**Re: ODOARDI – Vacant Lot  
22 Nethermont Ave. – New House Construction  
Tax ID: Section 122.16 – Block 4 – Lot 7**

G.E.S Revisions/Written Response to Comments addressing the comments received 03/18/2021

G.E.S Revisions/Written Response to Comments addressing the Planning Board Staff Report, dated January 24, 2020, and Revisions/Written Response to Comments Received from Kellard Sessions (Town Consulting Engineer), dated January 24, 2020.

TS - 1  
 SHEET 1 of 5

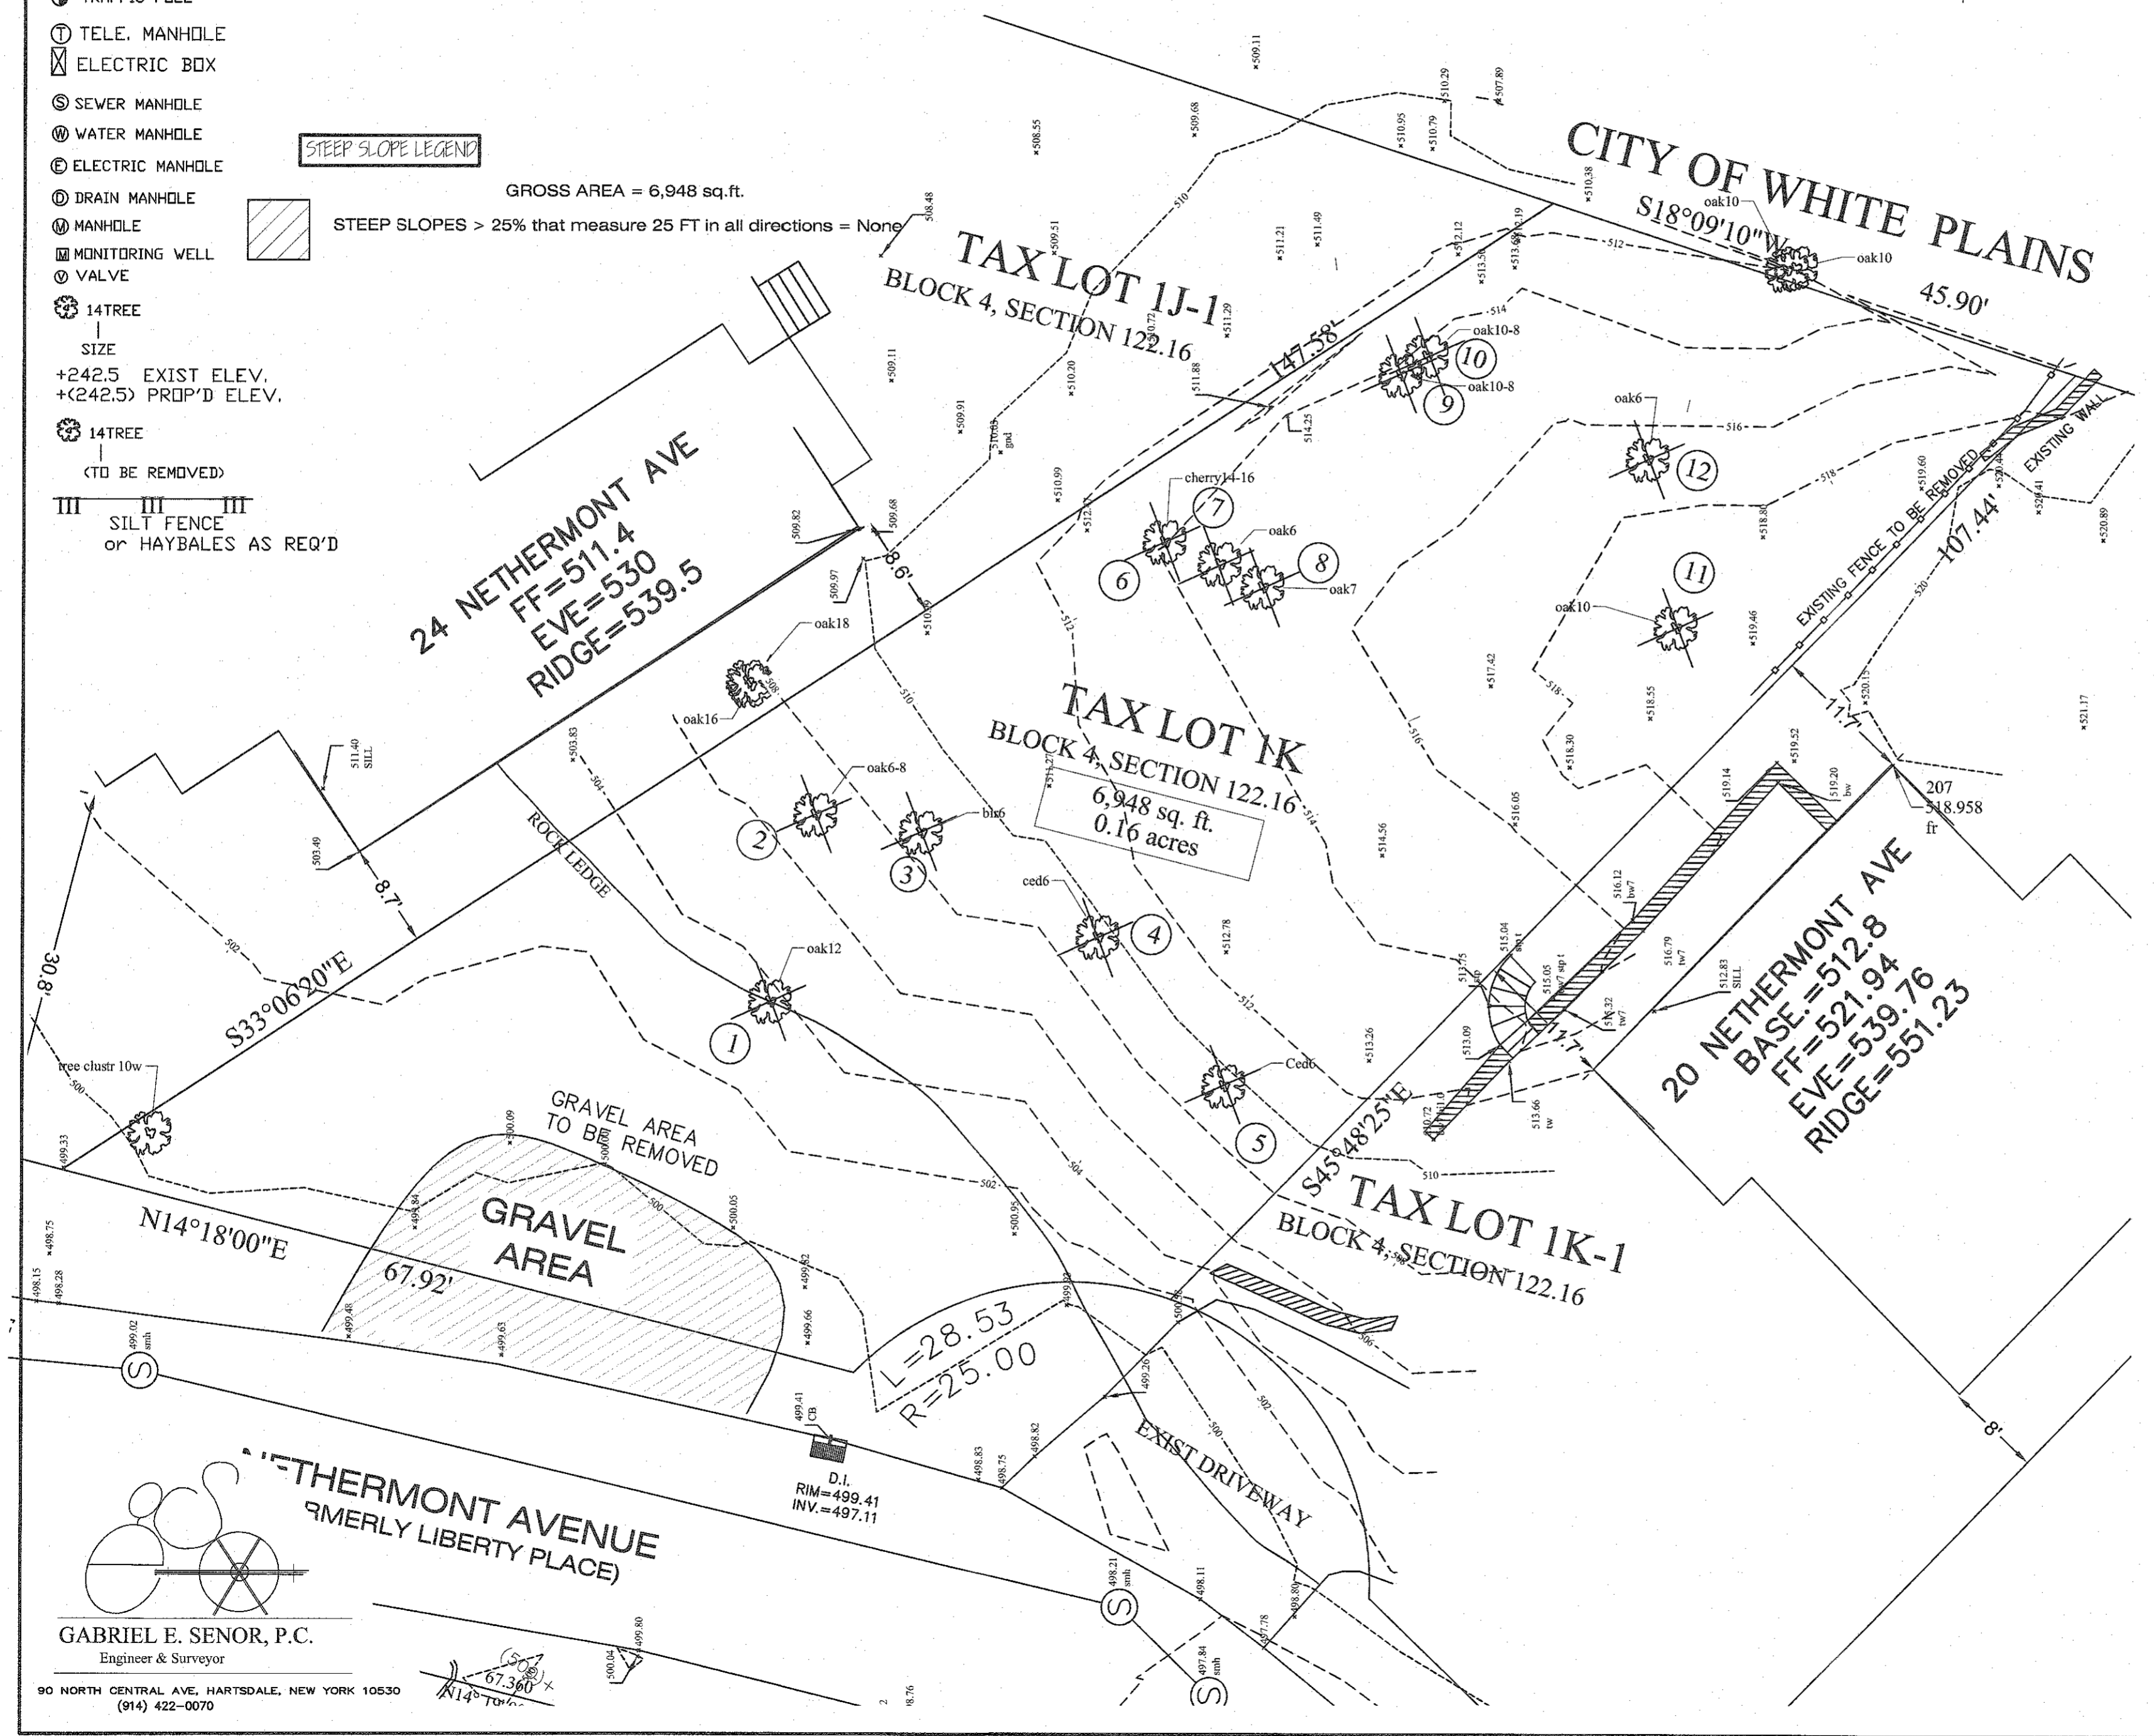
- The existing conditions are shown on the existing conditions and removals plan TS-1. The gravel limits are shown, and it is noted to be removed.
3. The applicant has submitted an Existing Conditions Plan (Sheet TS-1). It appears that some of the proposed improvements are shown on this plan. Please revise the plan, as necessary, to illustrate only the existing conditions on the site and proposed removals.

- Plan has been revised to show only existing conditions.
4. For clarity and ease of review, the applicant should prepare a site plan that includes all proposed improvements including, but not limited to, proposed residence, walkways, patios, driveway including dimensions, a zoning compliance table, the minimum building envelope illustrating building setbacks and dimensions, retaining walls and existing neighboring buildings and driveways. Proposed grading, utilities, erosion controls, etc., should be illustrated on separate plan sheets.
